**METROPOLITAN DEVELOPMENT COMMISSION
HEARING EXAMINER**

Case Number: 2025-CZN-844 (Amended) / 2025-CVR-844 (Amended)
Property Address: 127 East 34th Street (approximate address)
Location: Center Township, Council District #8
Petitioner: Hoosier Outreach, Inc., by Craig McCormick
Current Zoning: C-1 (TOD)
Rezoning of 0.11-acre from the C-1 (TOD) district to the D-8 (TOD) district to provide for a small apartment consisting of four units.
Request: Variance of Development Standards of the Consolidated Zoning and Subdivision Ordinance to provide for a small apartment with zero-foot east side yard and rear yard setbacks for a surface parking area (minimum five-foot side yard and 10-foot rear yard setbacks required).
Current Land Use: Undeveloped
Staff Recommendations: Approval with commitment.
Staff Reviewer: Marleny Iraheta, Senior Planner

ADDENDUM FOR DECEMBER 11, 2025 HEARING EXAMINER

AMENDED SITE PLAN

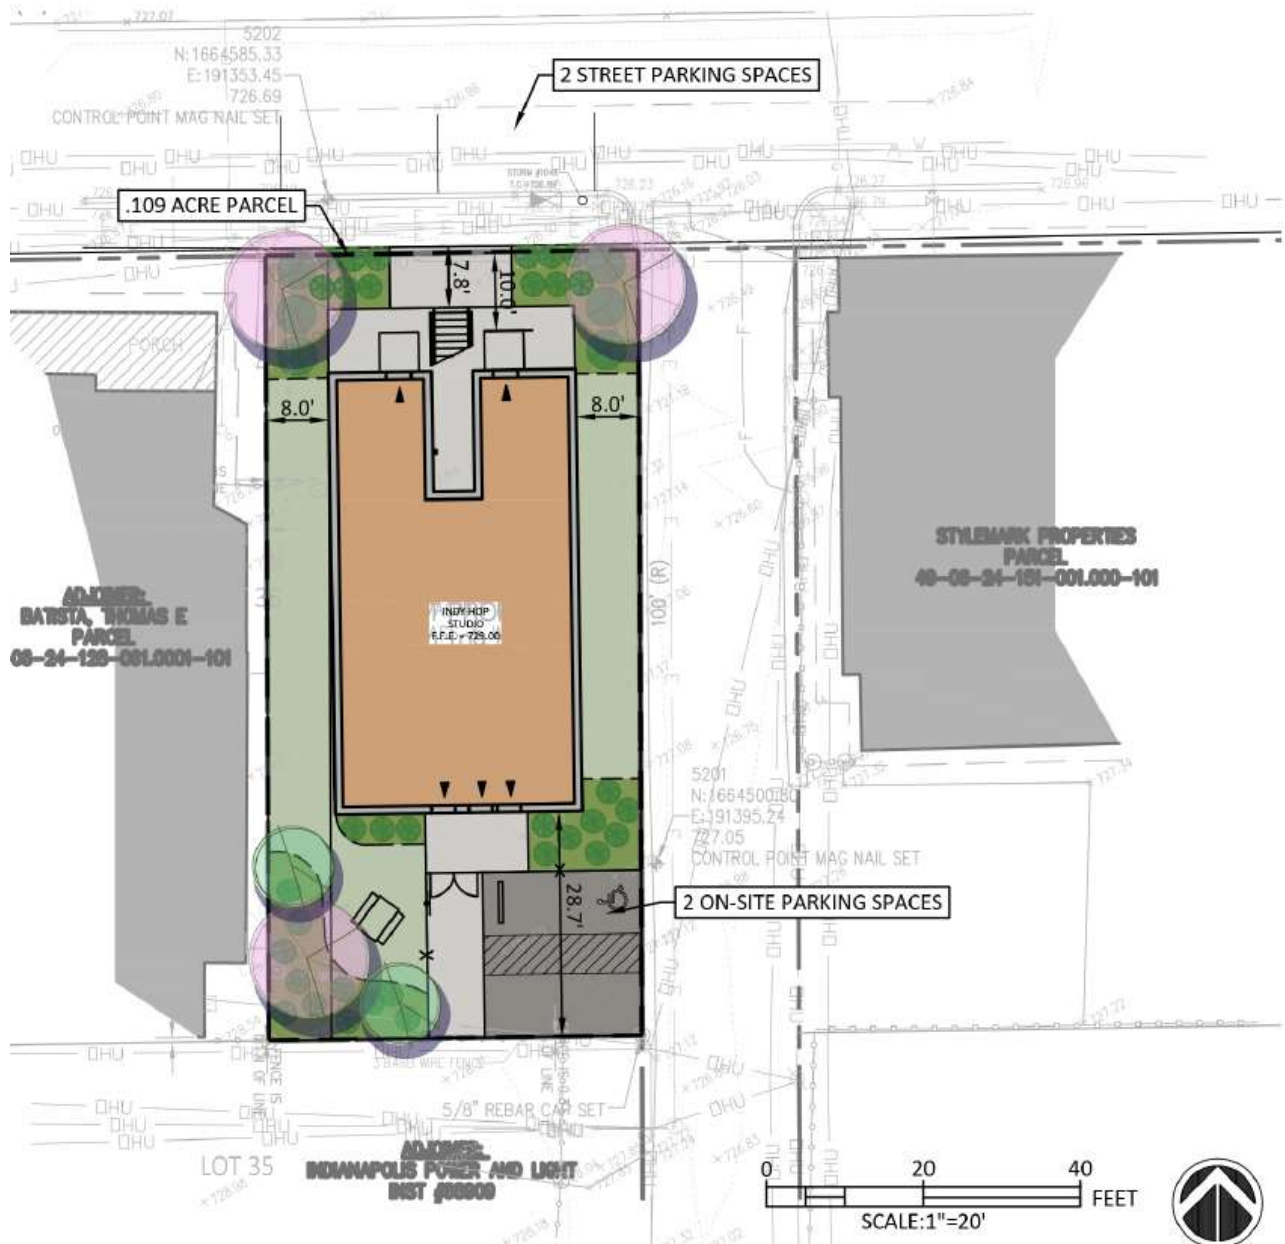
Amendment: The request was amended to rezone the site to the D-8 district instead of the previously requested D-5 district for a proposed small apartment consisting of four units. An additional zero-foot rear yard setback variance was added to address the relocation of the surface parking area.

Lastly, the petitioner was made aware that per TABLE 744-701-2: PRIVATE FRONTAGE DESIGN STANDARDS, any front entry feature cannot extend further than five (5) feet into the 10-foot required front yard setback. The final site plan will need to be adjusted to meet this standard unless a variance is sought at a later time.

Staff now **recommends approval of the request as amended** subject to one commitment proposed by the petitioner that parked cars on the property shall not encroach upon or impede the east alley. This commitment shall be reduced in writing on the Commission's Exhibit "B" forms at least three (3) days prior to the MDC hearing.

FIRST FLOOR PLAN

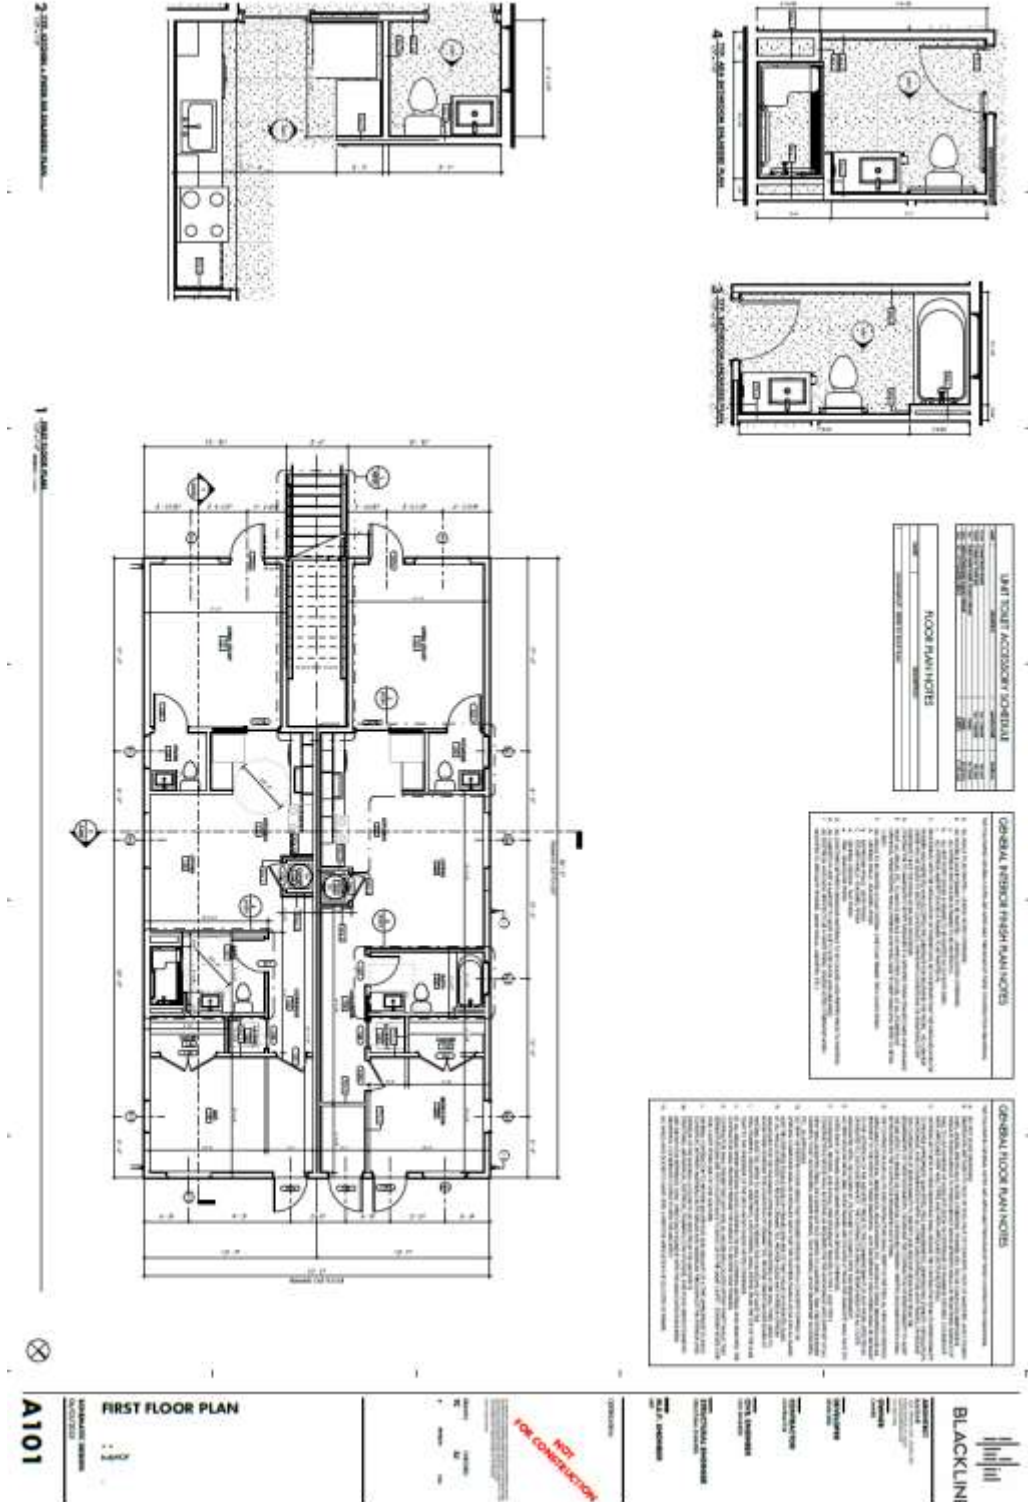
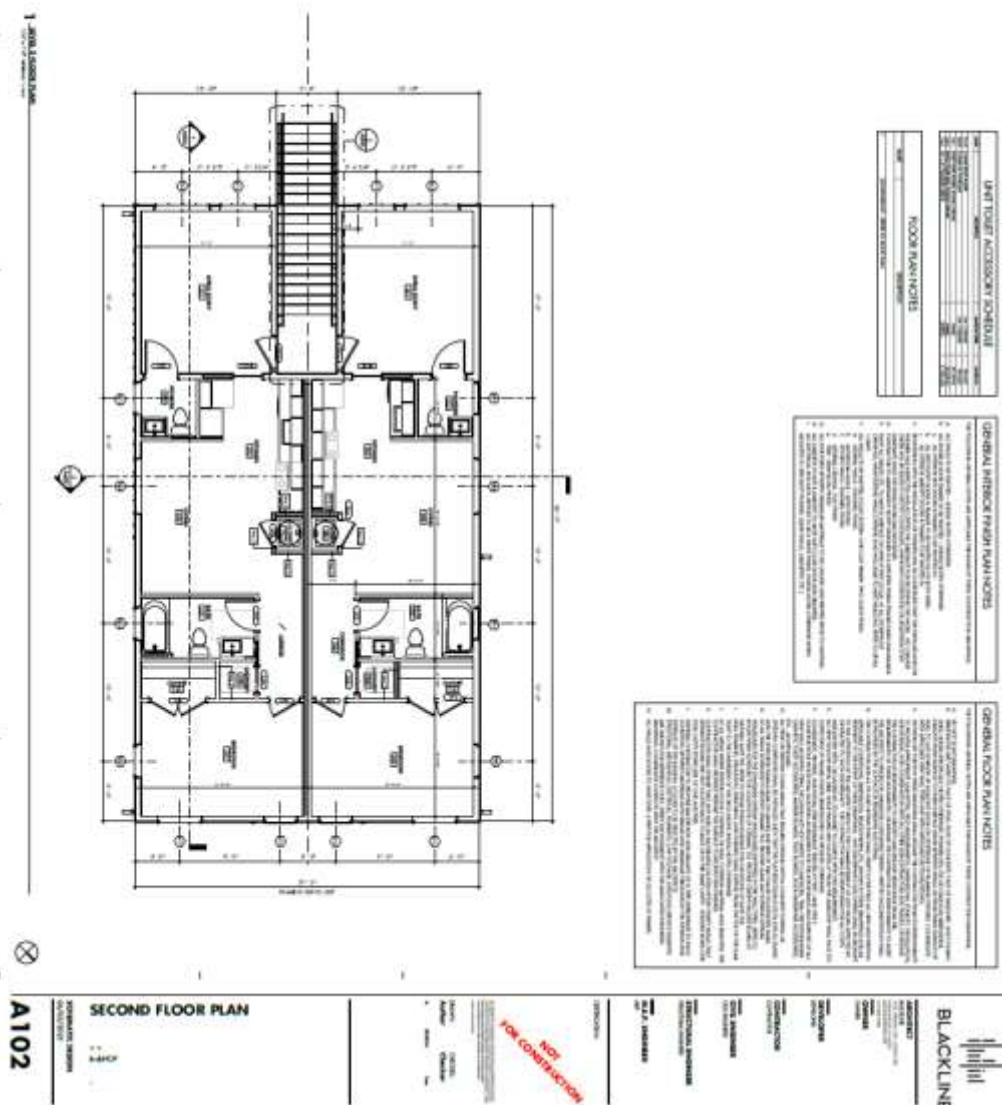
If the submitted plans represented a multi-unit house, which is defined by Current Planning staff as a residential building with a common entrance and exit with interior access to the units, then staff would support the rezoning and variance request associated with said multi-unit house.

However, the floor plans and elevation that were submitted at staff's request resulted in the discovery that the proposed building type would not be a multi-unit building as defined by staff. Instead, each individual unit would have its own exterior entrance and would therefore be classified as a small apartment.

Staff informed the petitioner of this discrepancy and recommended they amend the request to rezone the site to the D-8 district for a small apartment, which staff would support.
